## PACKARD MOTOR CAR COMPANY

March 5, 1930.

SUBJECT: FAN BELT ADJUSTMENT 626

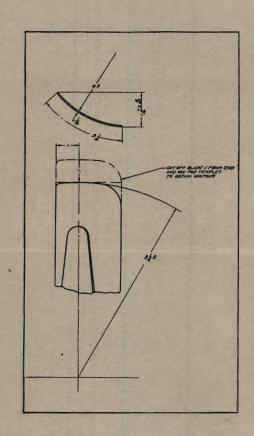
The accompanying cut illustrates the method by which this may be accomplished. Each fan blade is cut off 1" from the end so that the fan diameter is reduced from  $20\frac{1}{2}$ " to  $18\frac{1}{2}$ ". After cutting the end off the first blade the piece which is removed may be used as a marking template in order that the same amount may be taken from each blade and the running balance of the fan retained. The ends should be dressed with a file in order to remove any sharp edges which might cause an increase in fan noise.
